ADDENDUM NO. 1

ISSUE DATE: **May 3, 2018**

RE: **Sterling Hall Renovation for TREX Physics**
University of Wisconsin-Madison
Madison, Wisconsin
UW-Madison Project No. **0057-1701**
UWSA Project No. **A-17-003**

FROM: KEE Architecture, Inc.
621 Williamson Street
Madison, Wisconsin 53703

Sheet Number: **S101.2**

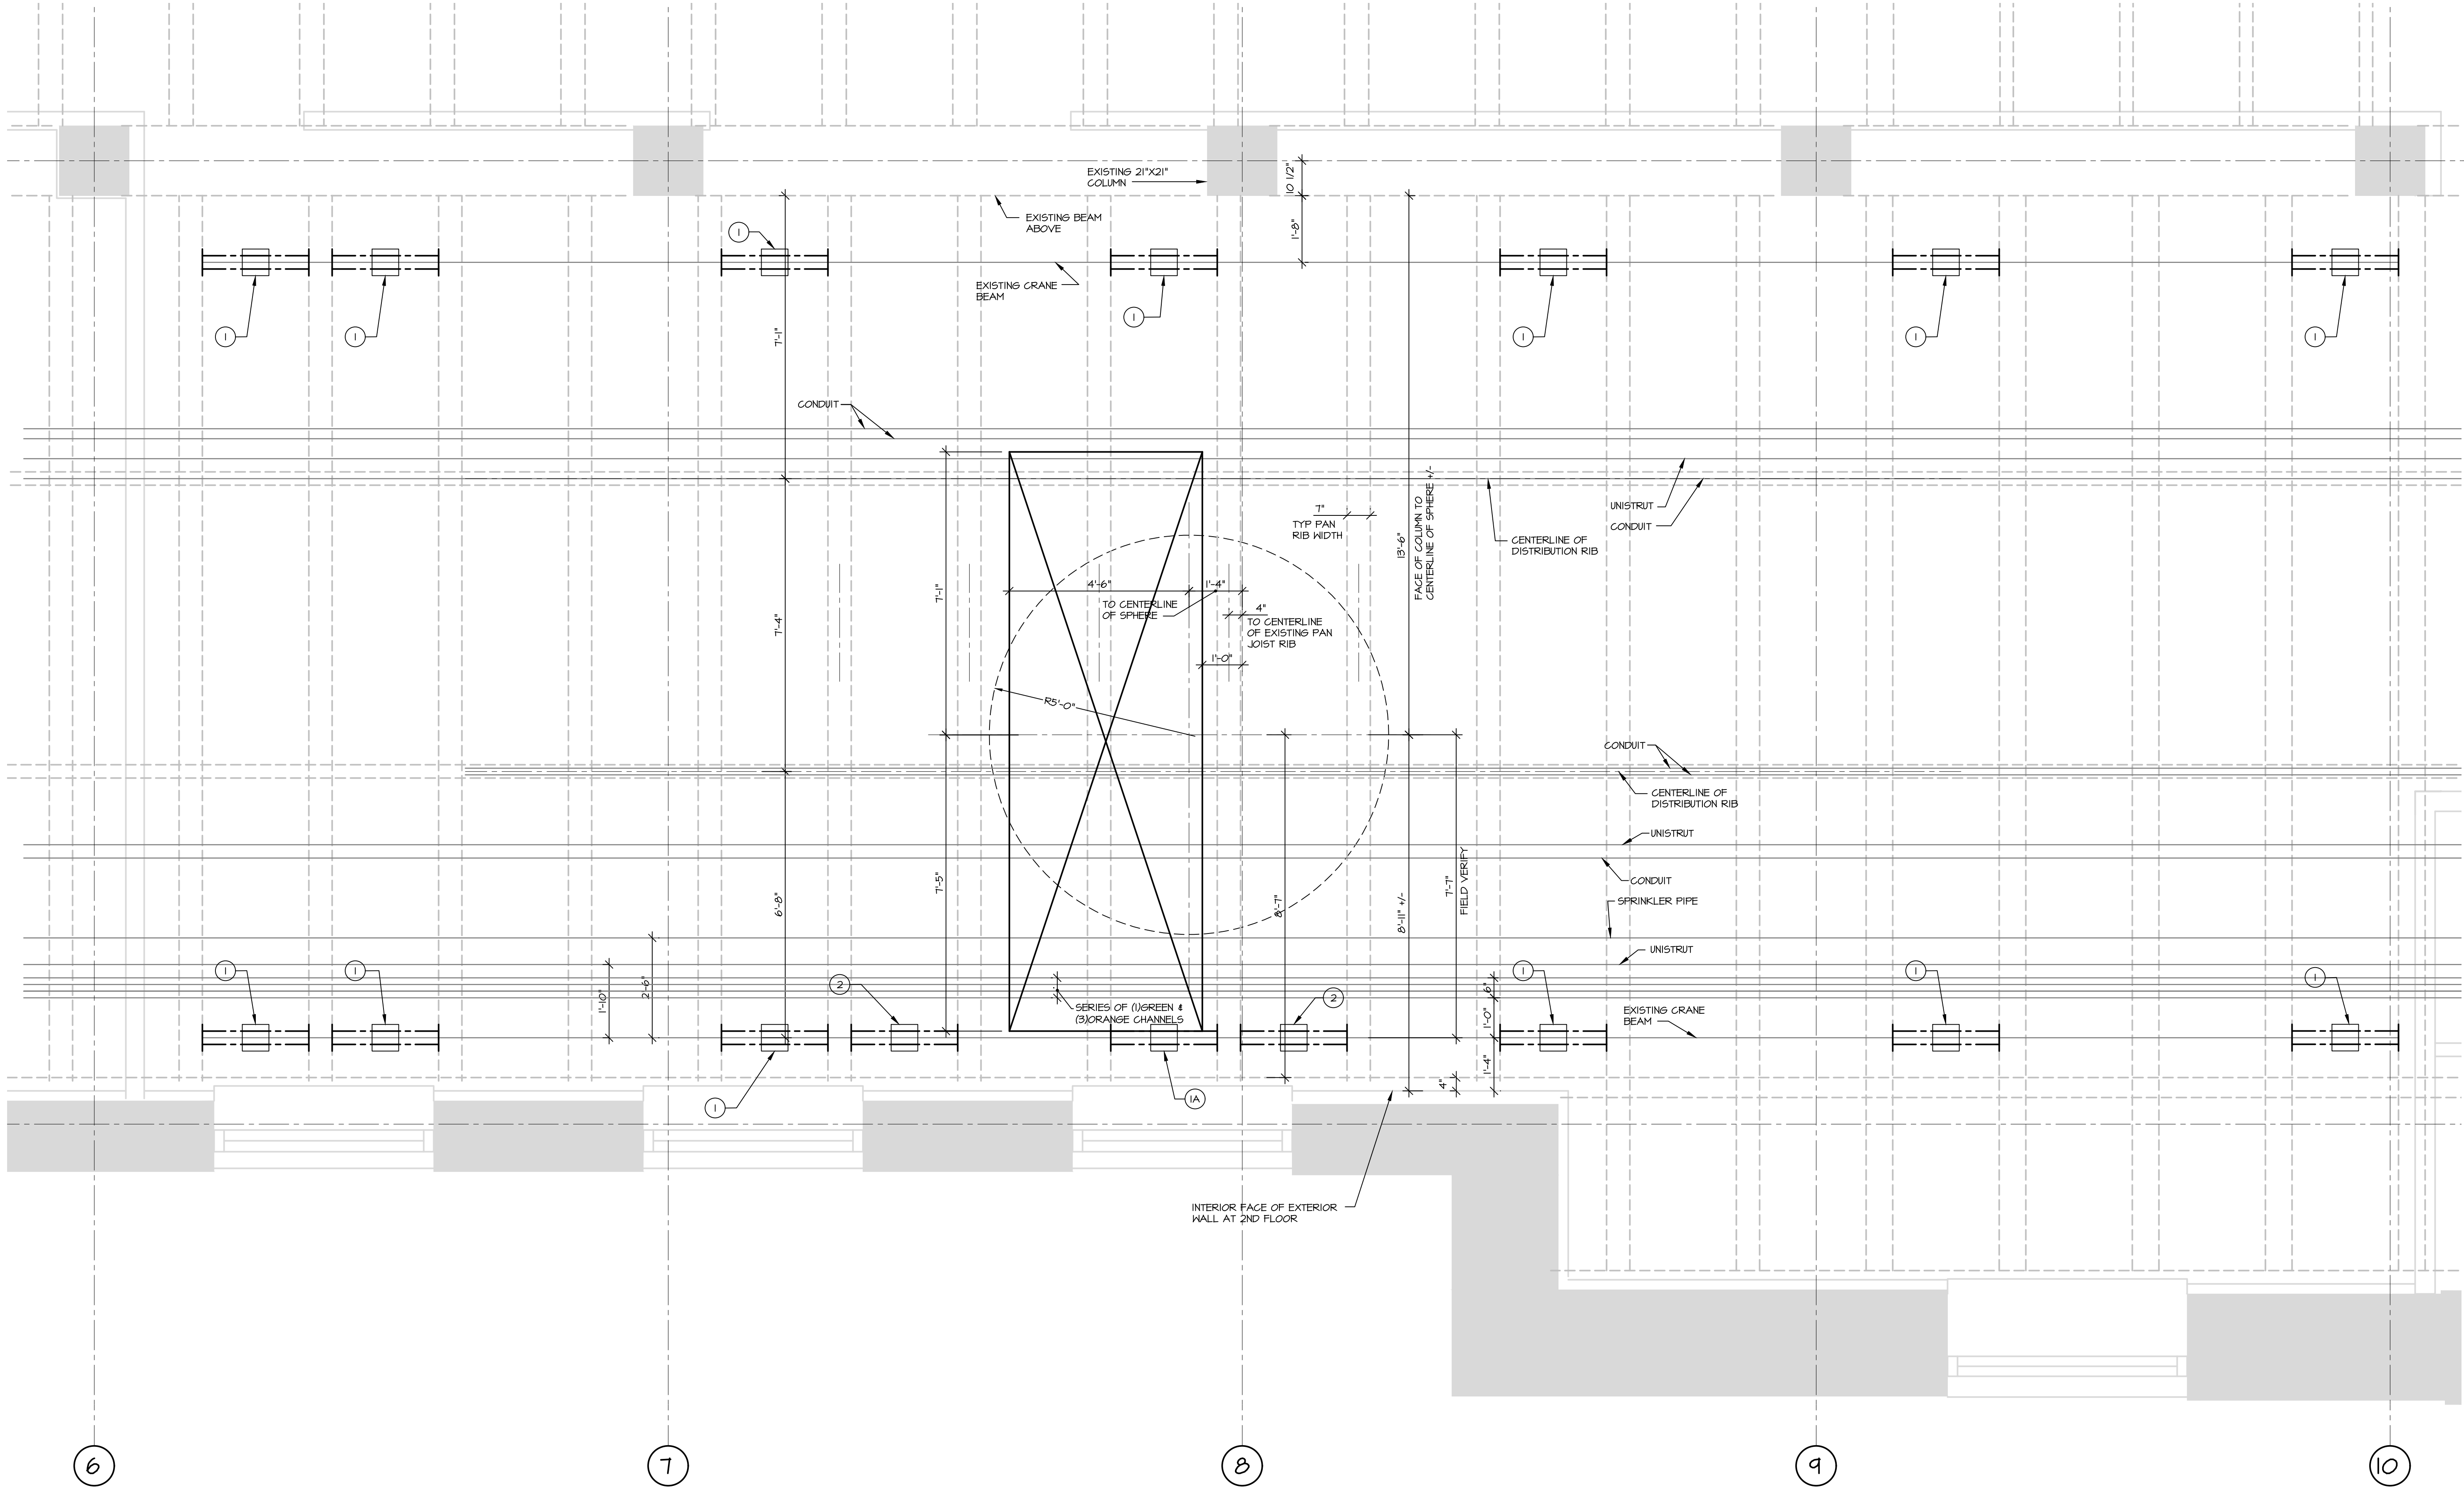
12. S102.2 – Enlarged Plan & Details (FS Option 2): Added Sheet.
 - a. Indicating configuration & details for FS Option 2.
13. S201.1 – Third Floor Framing Plan (FS Option 1): Replaced Sheet S201 with Sheet S201.1.
(Sheet name and number change only.)

Sheet Number: **S800.2**

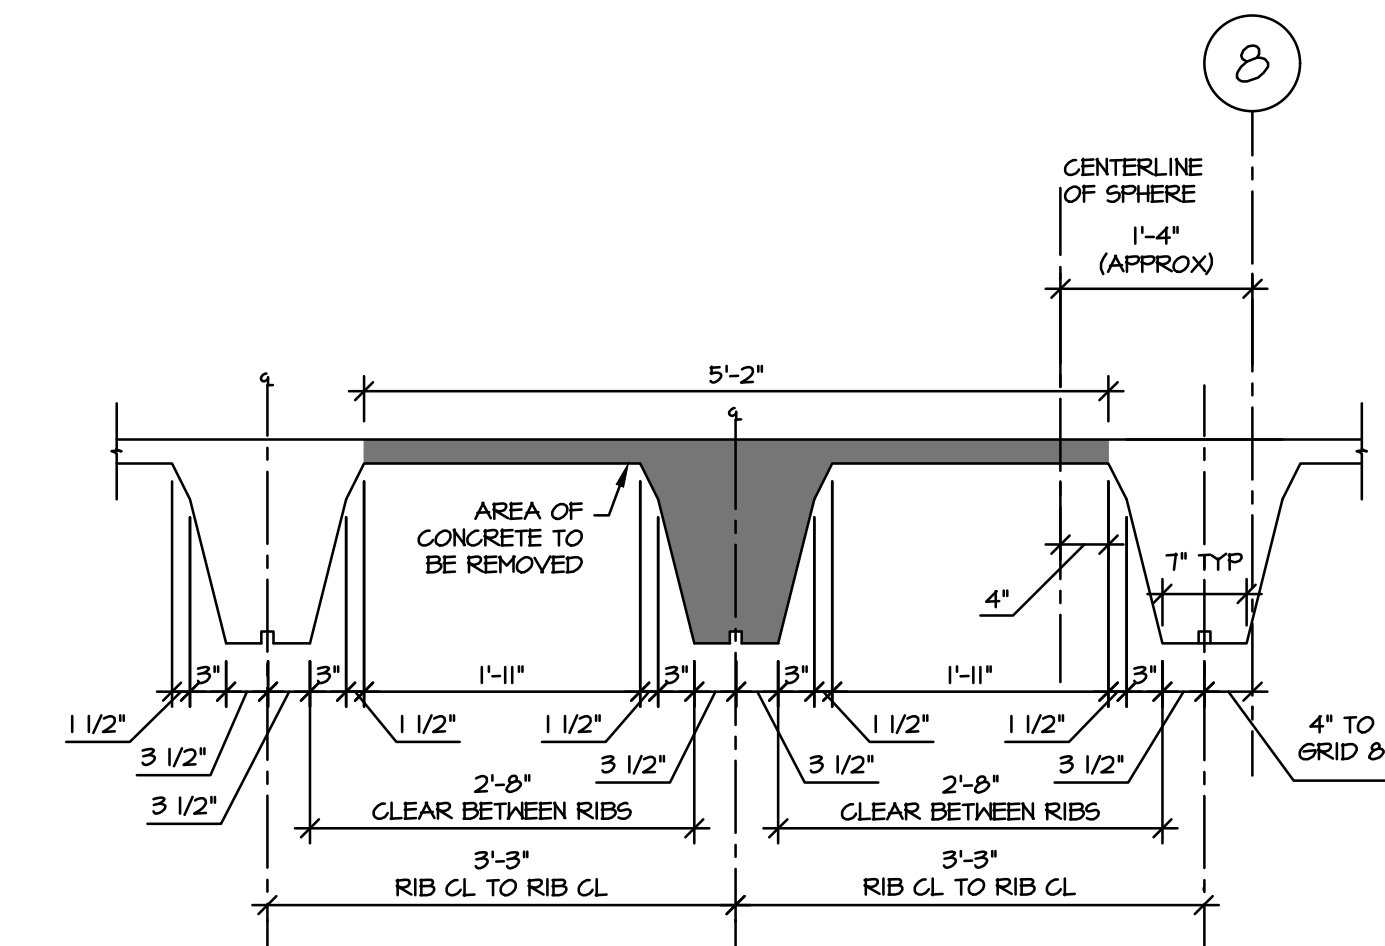
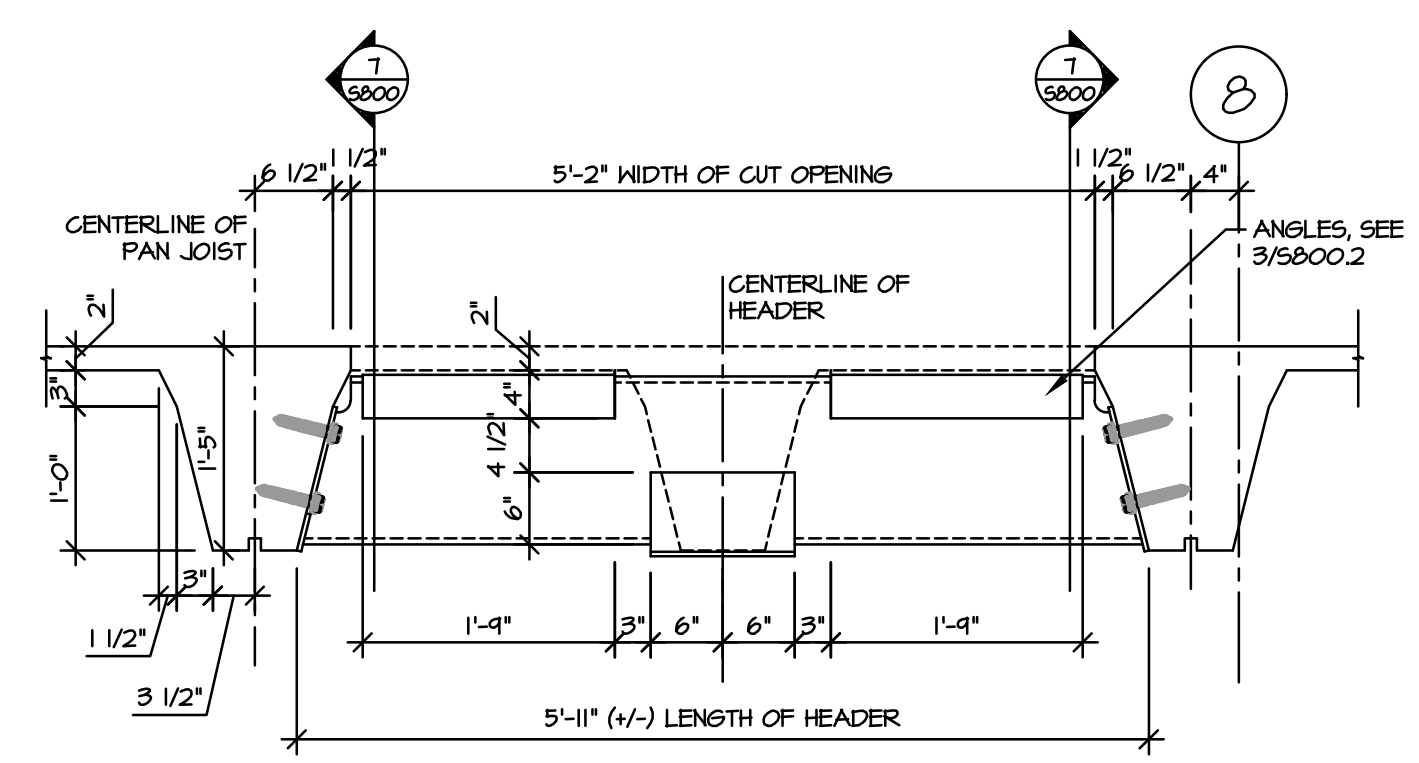
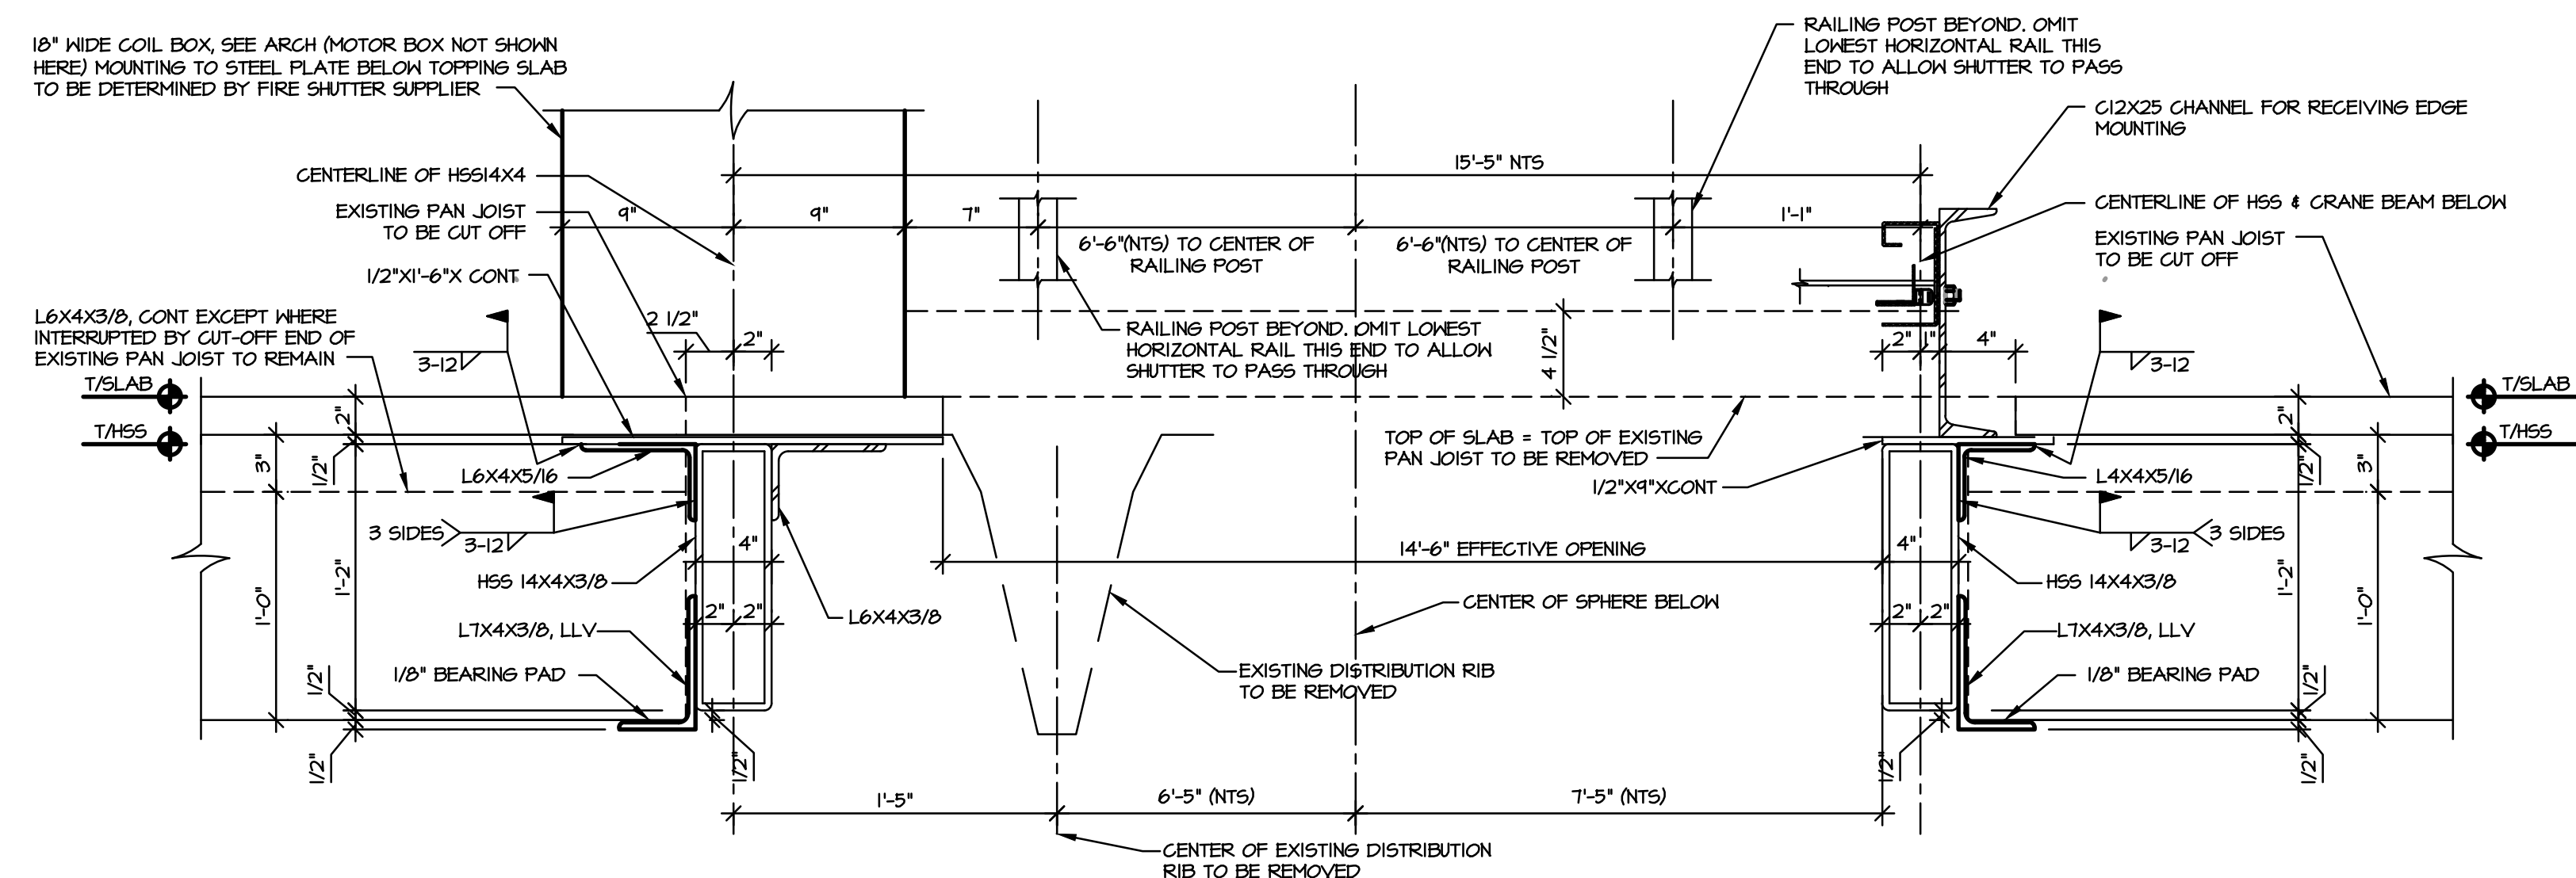
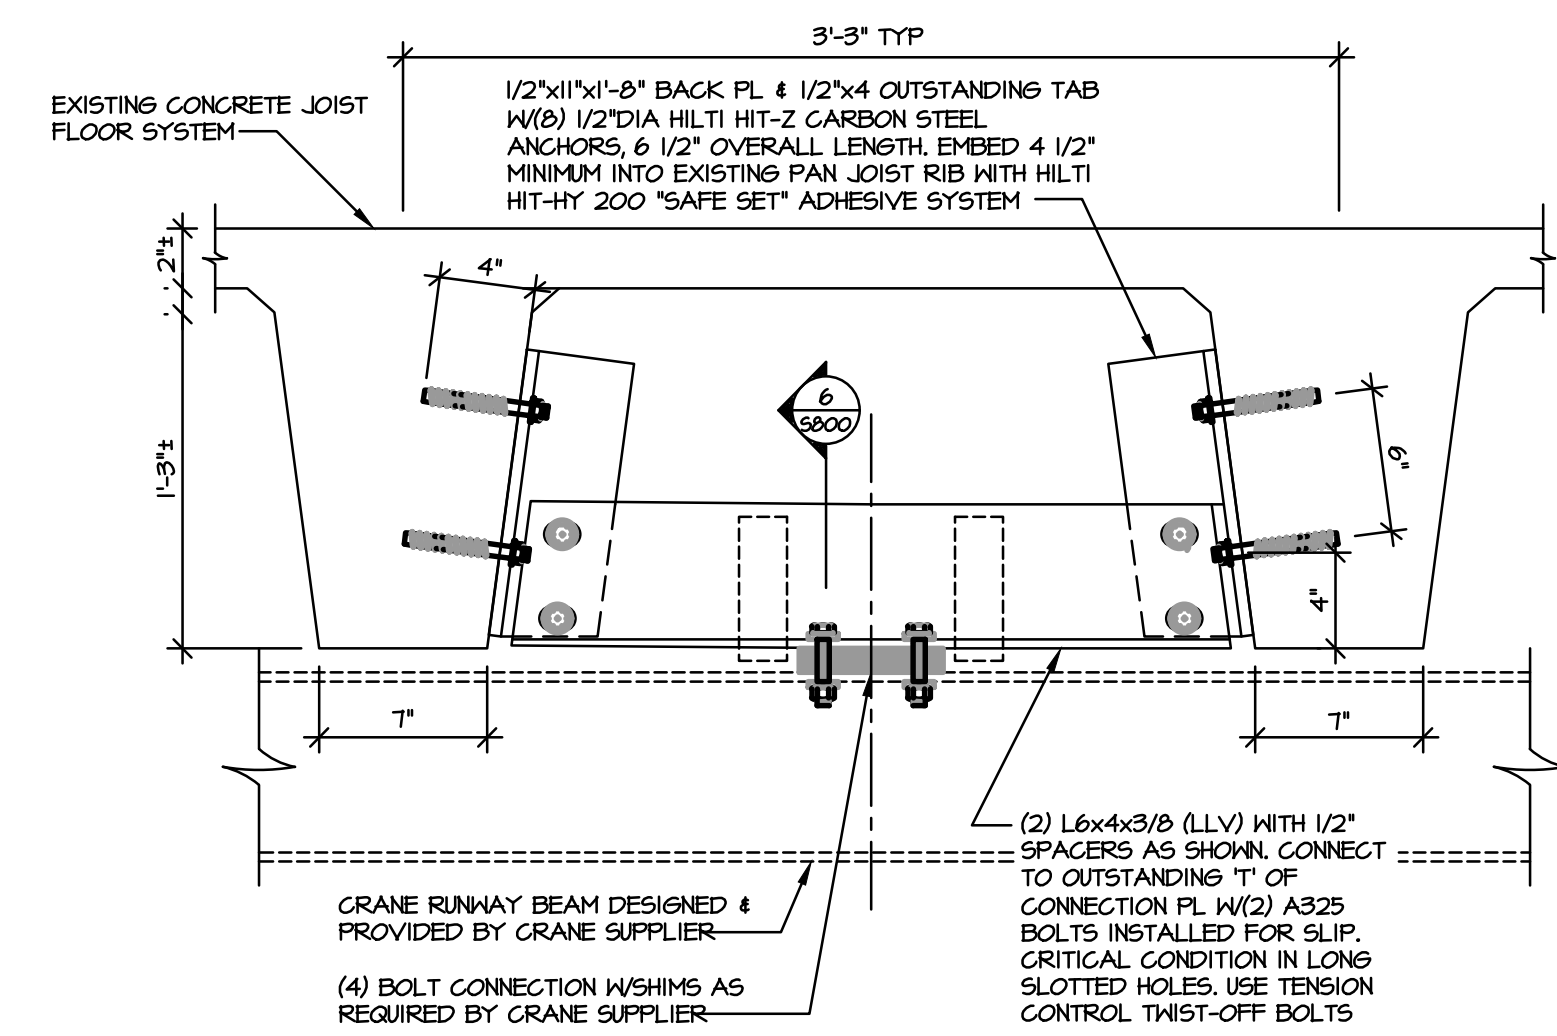
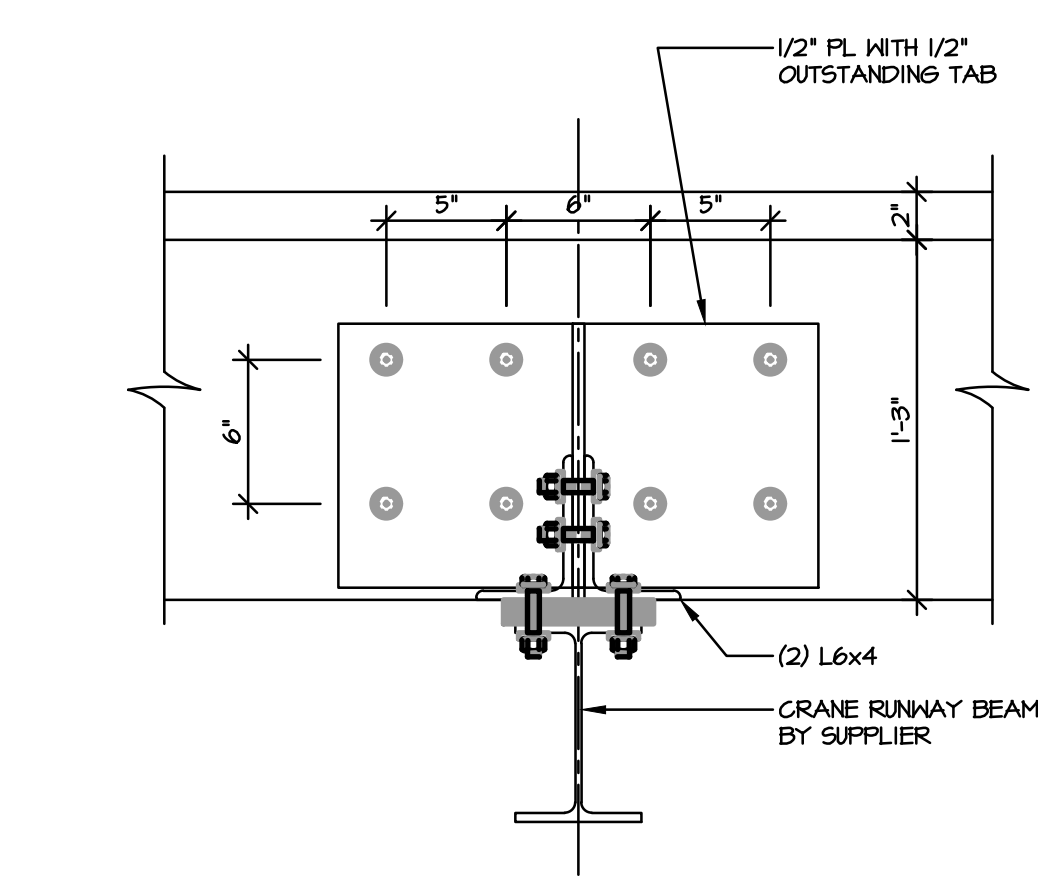
18. S800.2 – Details (FS Option 2): Added Sheet.
 - a. Details 1, 2, 3, and 4 this sheet are all substantially different for the FS Option 2.
19. A202 – Partial First Floor Plan (Demolition): Replaced sheet
